CERTIFICATE OF APPROPRIATENESS

Property: 1202 Ashland Street, Lot 19, Tract 20A, Block 182, Houston Heights Subdivision. The property includes a historic 3,018 square foot, two-story wood frame single-family residence and detached garage situated on a 6,600 square foot (50' x 132') corner lot.

Proposal: Alteration – Addition

This application proposes a 306 SF one story side addition to the existing residence providing an informal entry/mudroom and downstairs laundry. The addition will be connected to the garage via a covered walkway. The original corner is believed to be where the kitchen ends and therefore has been lost due to previous additions.

Side Wall Length and Insets (Addition and New Construction)

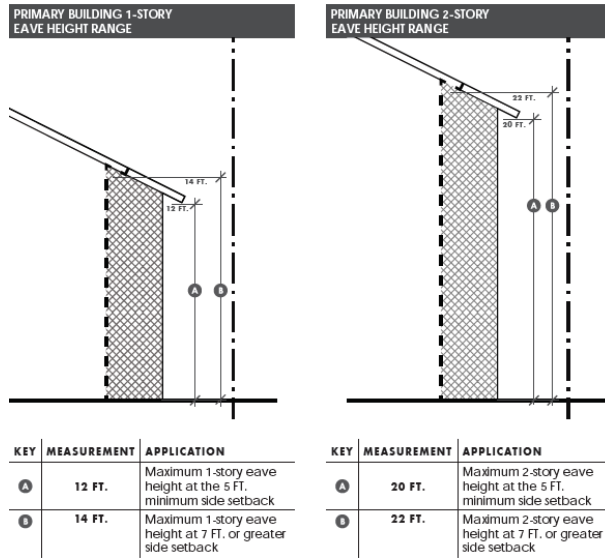
Original Corner is already gone due to previous additions

LOCATION OF ORIGINAL FRONT CORNER 2 (FC2)

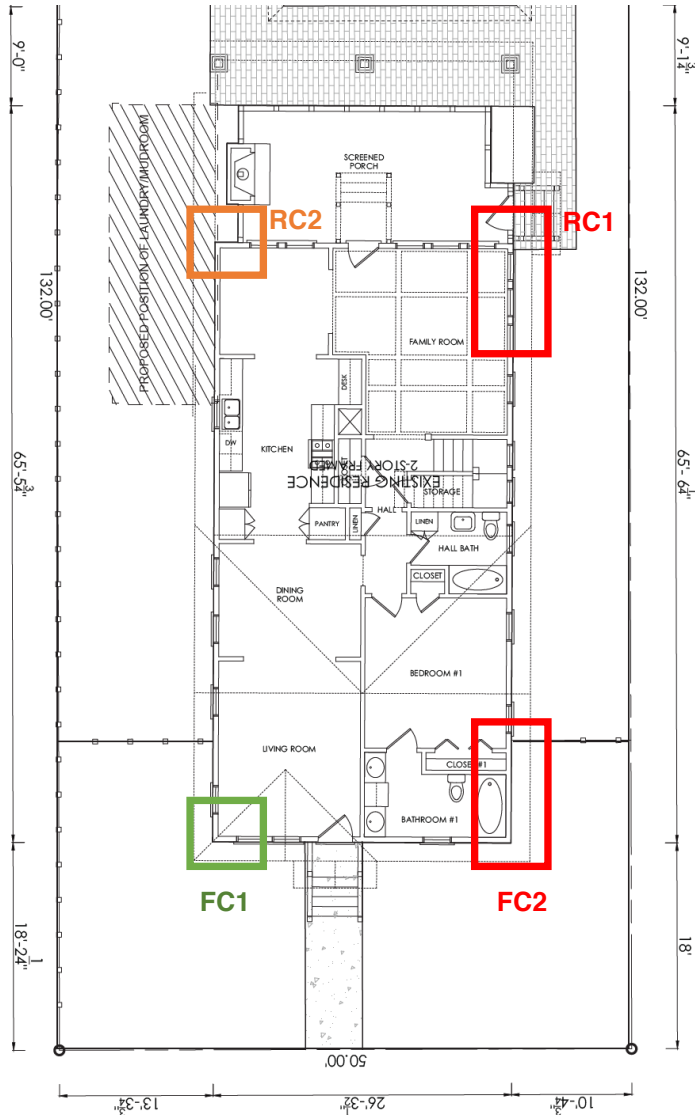
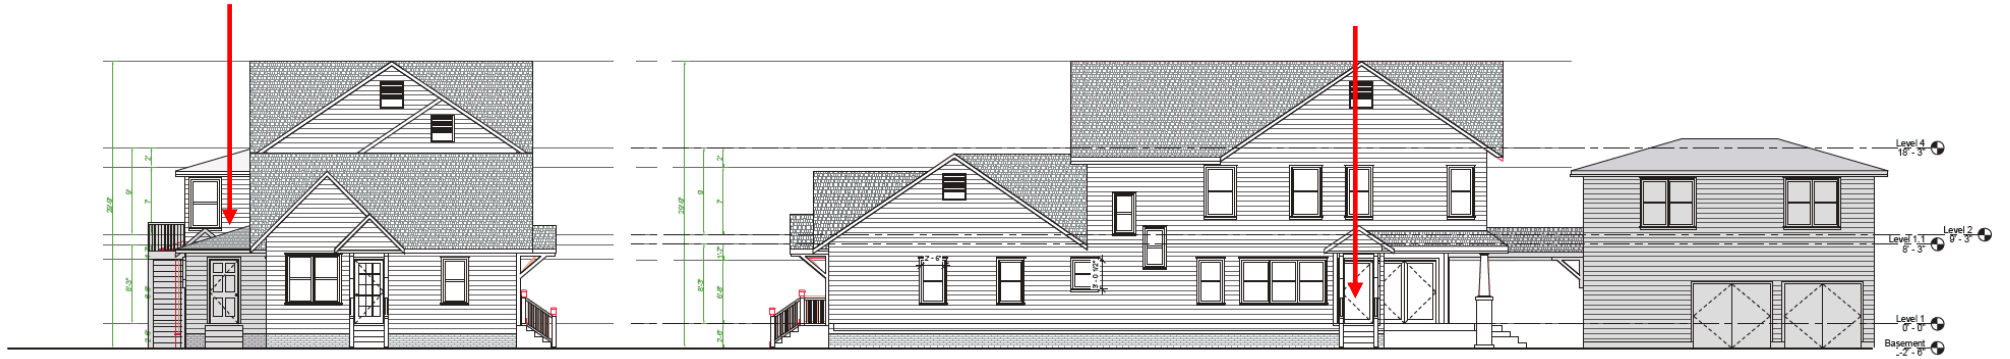
- Based on the available information, it is evident that at least 2 of the 4 original corners have not been retained over the building's history (refer areas highlighted in red).
- Front corner 2 (FC2) originally had a porch which was absorbed into the house to create an en-suite bathroom (date unknown).
- Rear corner 1 (RC1) has been integrated into the design of a 2-story addition and screened porch, circa 2013.
- FC2 and RC1, the altered corners, are both highly visible from the street, arguably already significantly impacting the Historic integrity of the building.
- Rear corner 2 (RC2) in proposed design is not visible from any vantage point.

PROPOSED NORTH ELEVATION
BOUNDARY TO NON-CONTRIBUTING HOUSES

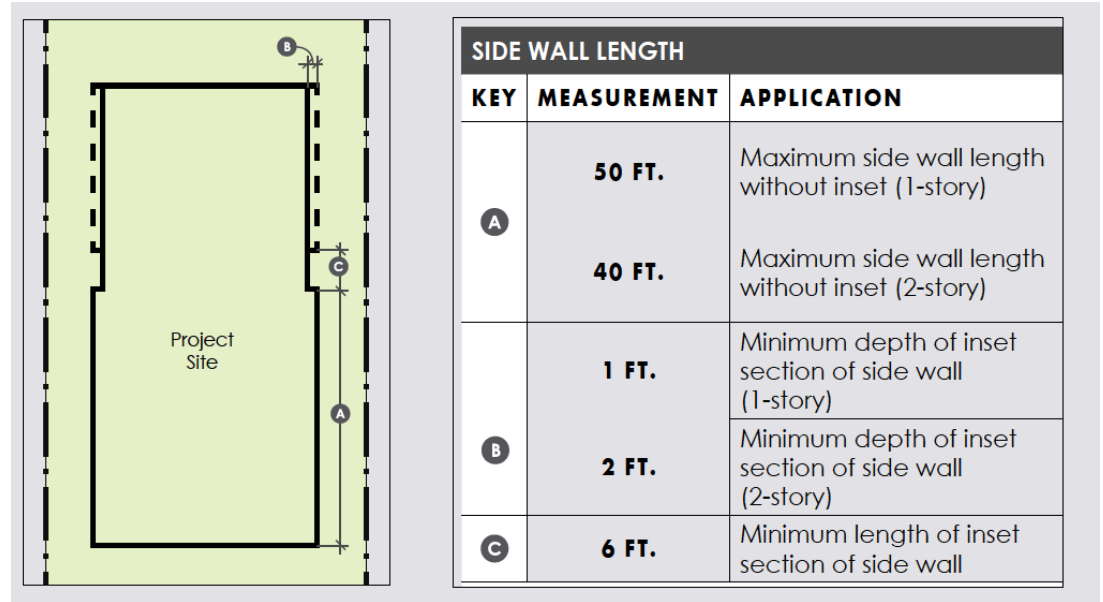
- Rear Corner 2 is currently not, and will not be, visible from East, West, or South Elevations (see above **RED** indicator arrow).
- Rear Corner 2 is currently not, and will not be, visible from the rear alley, Ashland Street or 12th Street.
- Currently only seen when onsite on the North elevation which runs alongside site boundary to neighboring properties.
- NB*Neighboring buildings are non-contributing structures.

- Prior renovation completed in 2013 does not meet the 2FT minimum inset requirements for a 2-story addition.
- Note, siding has also been replaced in this section of the Rear Corner 2.

1202 ASHLAND STREET FOR REVIEW

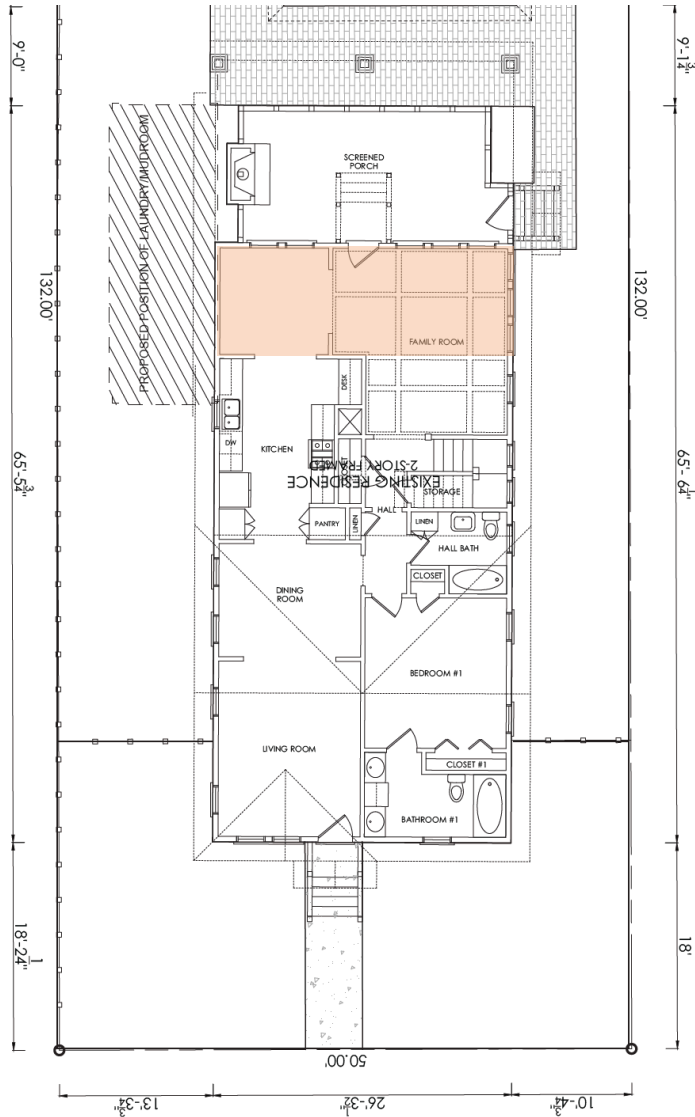
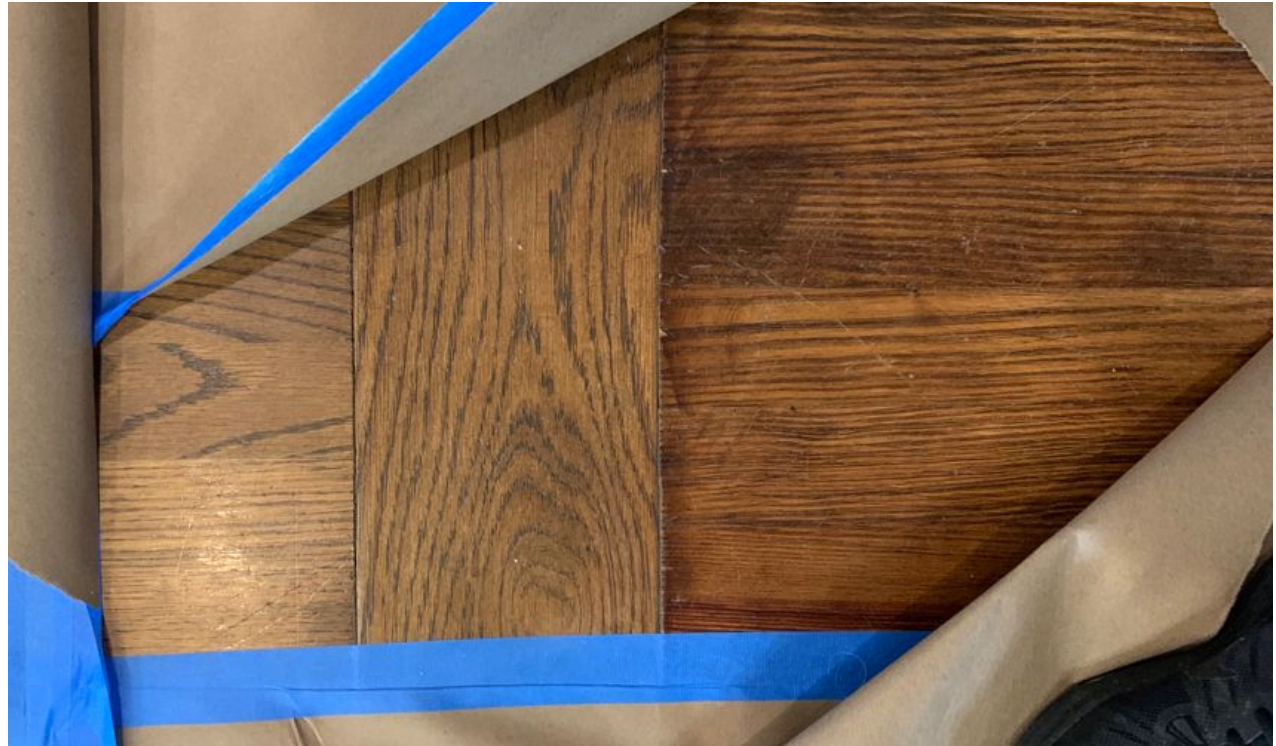
- Some onsite evidence to suggest area highlighted may have been either a porch or screened porch at some point in the building's history.
- Notice flooring change between kitchen and area highlighted (Refer photo below).
- Existing plan from 2012, shows this area to be open plan – unusual for bungalows of this era to have such a design.
- Suggests, none of the rear original corners have been retained over the building's history.

1202 Ashland - Construction photos

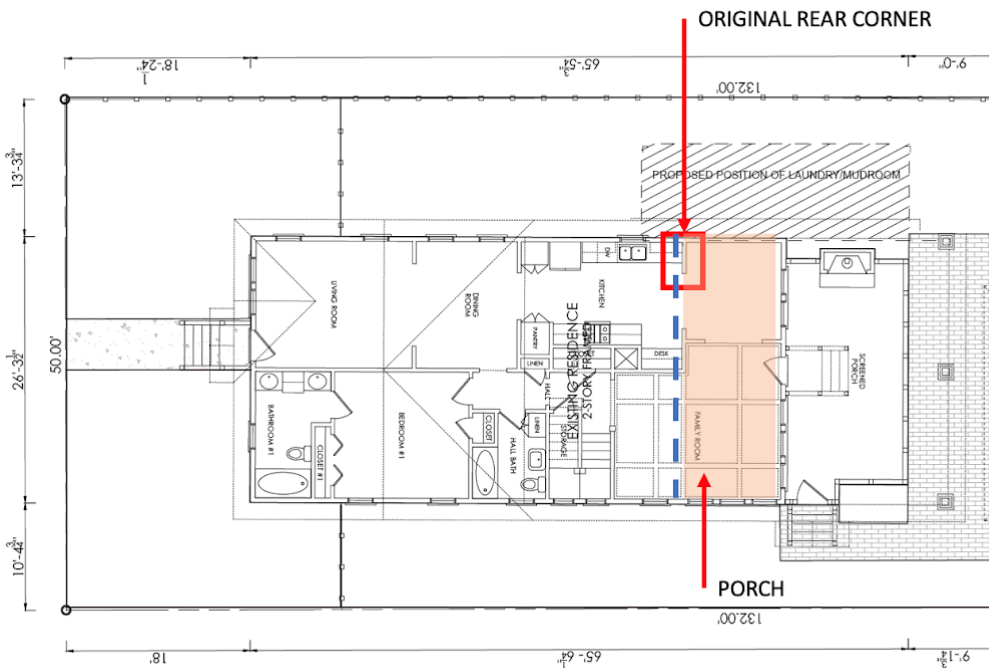
A house this size, from original corner marked below, wouldn't have had a rear porch that big. Big porches were more for up front than in the rear back in the day. If I had to put money on it, I'd say it was an addition to the house some time ago. With all the windows...sun room?

Can you speak to - in your opinion - if the rear room was a porch at some point that's been enclosed? That's the main issue. Basically is the rear corner (that existed in 2012) original OR was it as per diagram below.
